**We thank Dr Guillem Domènech-Gil for the thoughtful and constructive comments, and we are grateful for the positive feedback on the engineering quality and user-friendliness of the *Pondi*. Below, we respond point by point and outline the changes made to the manuscript accordingly. We will wait to upload the revised manuscript until we get the second reviewer's comments.**

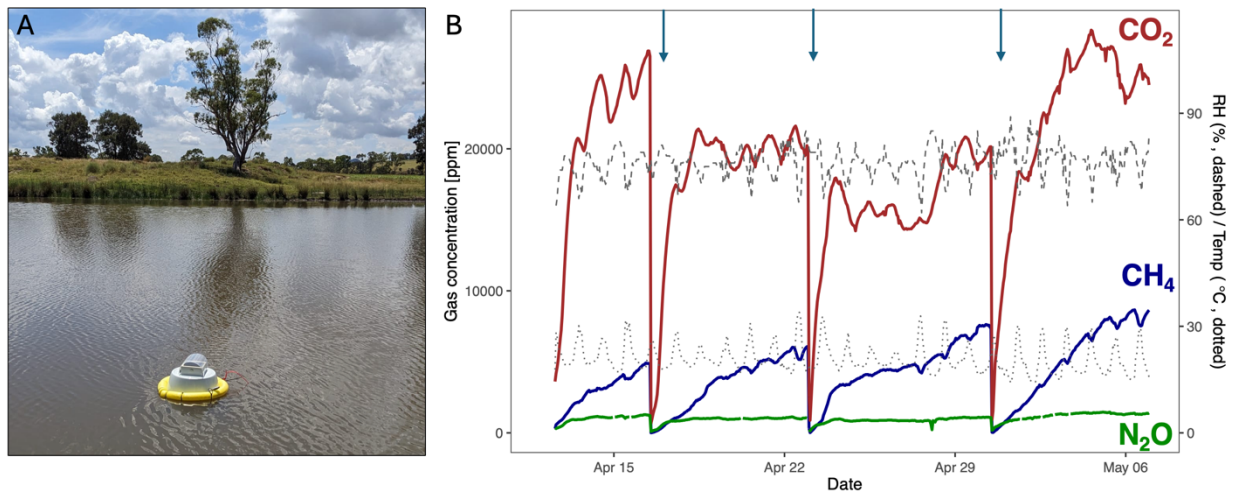
The field measurements and observations are relevant to validating Pondi, while missing data may induce thoughts of hidden information. To remove this residual possibility, could you include temperature and humidity data in Figures 6, 7, and 8? Do you have long-term terrestrial flux measurements including the different used sensors? Did you notice long-term drift in any of the sensors used? Could saturation values vary over time as seems to happen in Figure 6 and 7?

We have now added temperature and humidity data as additional panels in Figures 6, 7, and 8 to aid interpretation (see below).

While long-term drift is an important consideration, our typical deployment periods thus far have been around one month (see Fig. 6). Although this period is too short to assess long-term drift conclusively, we observed no significant signal decay or instability in any of the sensors during this timeframe. Also, we recommend monthly maintenance visits to clean the sensors and chamber surfaces due to algal buildup and biofouling, especially in aquatic settings. These visits provide a natural opportunity to perform routine recalibration, which helps minimise any long-term drift that might otherwise accumulate.
